Rezoning Transportation Analysis

Petition Number: 2021-079

General Location Identifier: 15705136

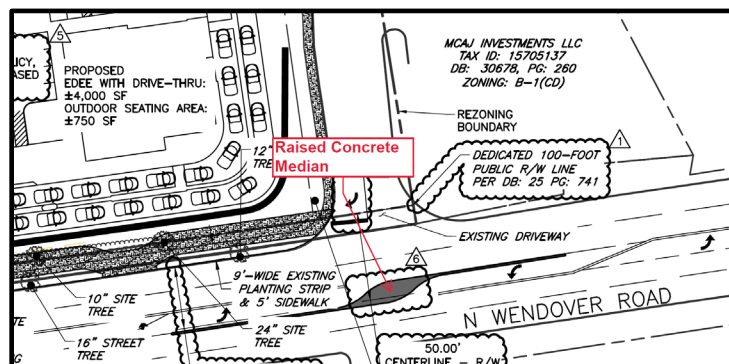
- Curblines:** The proposed zoning district has a setback measured from back of the existing or proposed future curblines.
 - North Wendover Road:** The future location of curb and gutter is in its existing location.

Label and dimension the curb and gutter from the centerline for each road on the site plan.
